PUBLIC HEARING/WORKING SESSION MEMORANDUM

PETITION #29-21

145 Warren Street

Special Permit/Site Plan Approval to allow four single-family attached dwellings with dimensional waivers, retaining walls greater than four feet in height, dimensional waivers for parking facilities with over five stalls and to waive one parking stall.

Proposed Site Plan

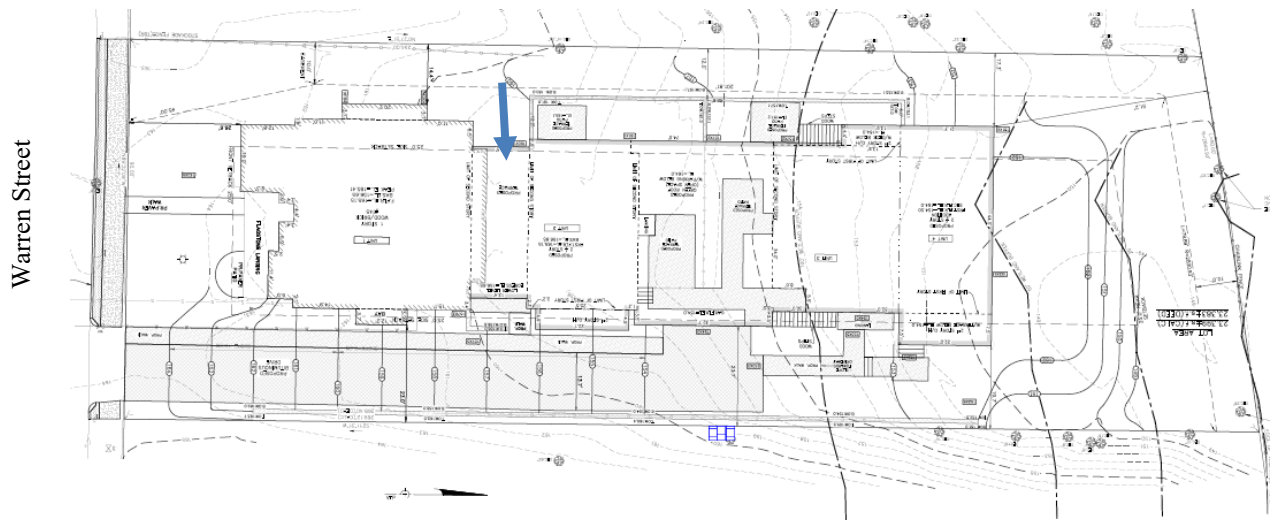
Following the April 6, 2021 public hearing, the petitioner submitted revised plans indicating a break in the massing between Units 1 and 2, as well as one less parking stall in the shared garage. While the revision of the structure does not constitute additional relief, the reduction in one parking stall requires additional relief to waive one parking stall, resulting in seven stalls, where eight is required.

The revised plans indicate a break in the massing between Units 1 and 2. Instead, a patio between Units 1 and 2 is proposed and is intended for the exclusive use of Unit 1. The petitioner is still proposing a lower-level connection from Unit 1 to Unit 2 via a laundry room in Unit 1 and a mud room in Unit 2.

First Floor/Garage Plan

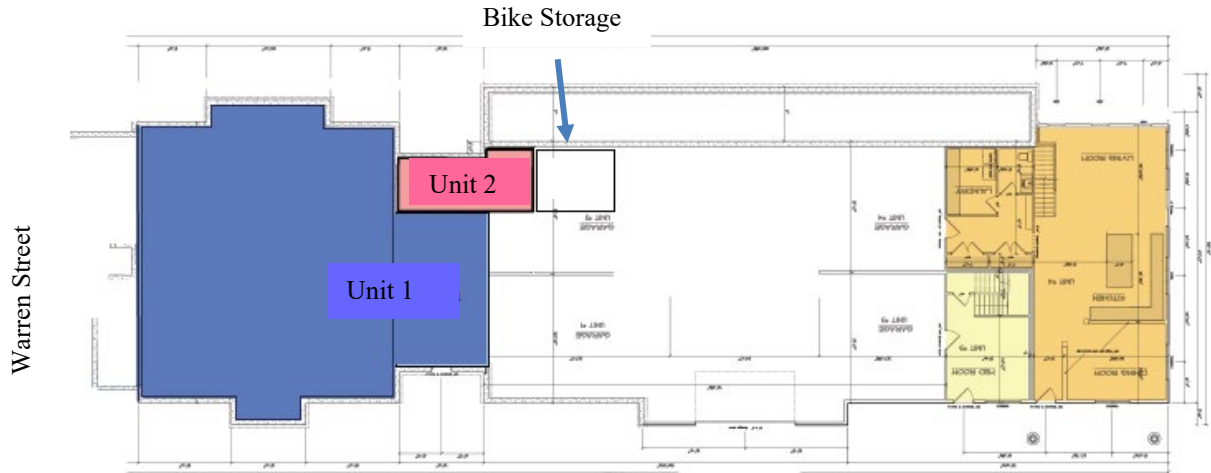
The revised plans include a reduction in one parking stall for Unit 2, all other units will have two parking stalls. The petitioner is proposing bike storage for all units instead of the eighth parking space. The petitioner stated that the bike storage will be constructed in a way in that it cannot be used for an additional parking stall.
